DOMINION ENERGY KEWAUNEE, INC. (DEK)
KEWAUNEE POWER STATION
RESPONSE TO REQUEST FOR ADDITIONAL INFORMATION
REGARDING INSERVICE INSPECTION THIRD 10-YEAR INTERVAL LIMITATION TO
EXAMINATION RELIEF REQUESTS

RESPONSE TO REQUEST FOR ADDITIONAL INFORMATION
REGARDING INSERVICE INSPECTION THIRD 10-YEAR INTERVAL LIMITATION TO
EXAMINATION RELIEF REQUESTS

Dominion Energy Kewaunee, Inc.
Kewaunee Power Station

FIGURE 2
RR-G-7-71 SUPPLEMENTAL

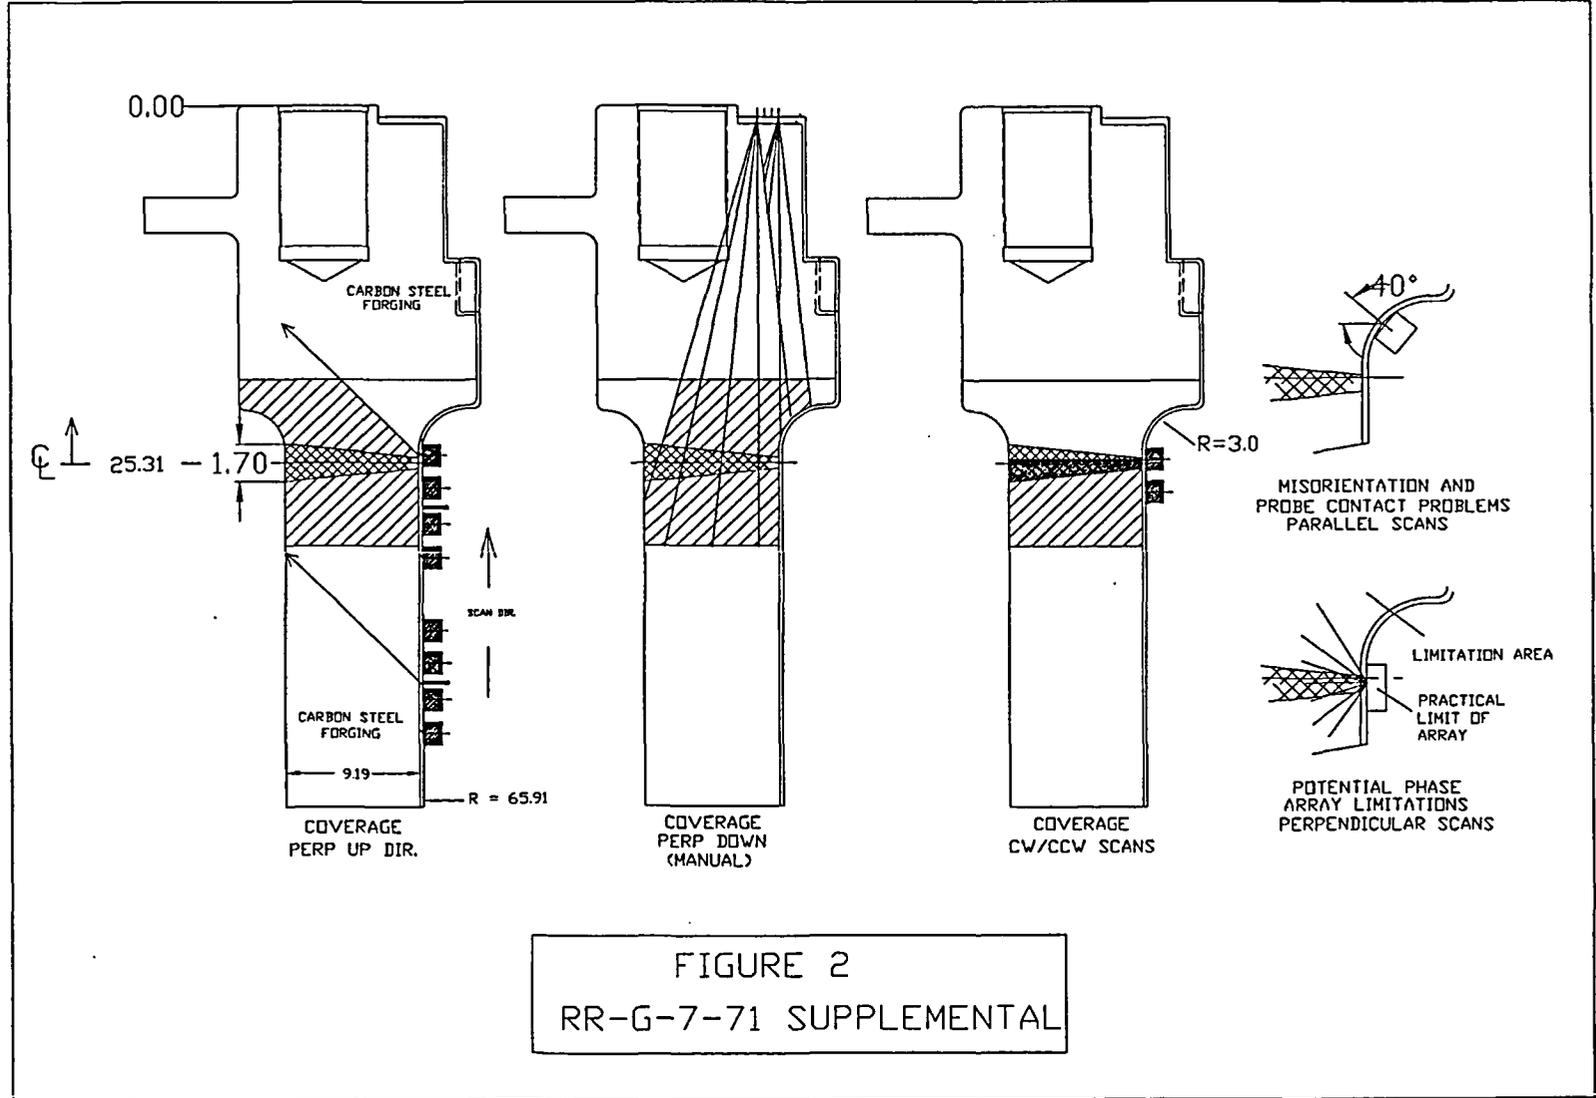
- 2.8.1 Provide clarification as to why a full-vee path examination or other technology such as phased array ultrasonics, could not be performed, and whether this full-vee path examination or phased array technology would increase volumetric coverage.

The flange to shell weld RV-W1 was examined using ASME Boiler and Pressure Vessel Code Section XI Appendix VIII approved techniques to the extent practical considering the component geometry. Access is provided from the reactor vessel ID surface for automated examinations, and from the flange seal surface for manual examinations. The combination of automated and manual examinations produced coverage of 74.4% of the examination volume. The limiting factor is the taper transition on the ID surface at the junction of the weld joint and the flange (Reference Cross-Section view, Figure 2, RR-G-7-71 Supplemental).

Other exam methodologies such as Phase Array and modified standard techniques such as using a single element full-vee path arrangement were evaluated and determined to be ineffective in providing any meaningful additional coverage. The problem is that the taper transition is curved with a 3-inch radius. This is a somewhat unique design for Westinghouse PWR vessel flange. The curved taper transition does not allow for proper contact of the transducers in either perpendicular or parallel scans. For parallel scans, scanning about the taper would result in a severe miss-orientation of the examination beam with respect to the volume (Figure 2). This is the biggest contributor to the coverage limitation. In perpendicular scans, a phase array probe would be limited and even shallow angle approaches would not reach the volumes of forging base metal surrounding the curved taper transition. Full-vee path techniques are not qualified to ASME Section XI Appendix VIII by any PWR vendor and may only increase coverage 3%-5%. The efficacy of this particular approach has not been proven by qualification, and it is the preference of DEK to apply only qualified automated exam techniques for the remote mechanized scans from the ID surface.
